Docket Item #9  
BAR CASE #2006-0231

BAR Meeting  
October 25, 2006

**ISSUE:** Addition and alterations

**LOCATION:** 310 North Fayette Street

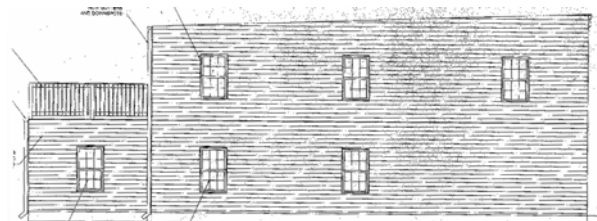
Generally, Staff is supportive of the general thrust and intent of the proposed addition and alterations. However, a number of the details of the proposal presented in the drawings appear to be problematic. First, the addition is detailed to have wood siding “to match existing”, but the main block is clad in aluminum siding. Staff believes that the project would benefit by specifying the siding that will be installed on the addition as well as the treatment of the siding for the historic main block. Second, a new window is detailed on the north elevation of the new addition. The building code would require that such a window have a one hour rating which cannot be achieved with the Pella windows specified for the other windows on the house. Further specification for this window is required.

Some of the proposed alterations to the existing house are inappropriate. The six-over-six windows proposed as replacements should be either one-over-one or two-over-two or two-over-one to reflected the historic period of construction of the house. Second, six panel Colonial Revival style front door is also inappropriate for a late 19<sup>th</sup> century house. Staff would recommend that a more architecturally appropriate door be specified.

Given these concerns, Staff recommends deferral of the application for further refinement of the project details.
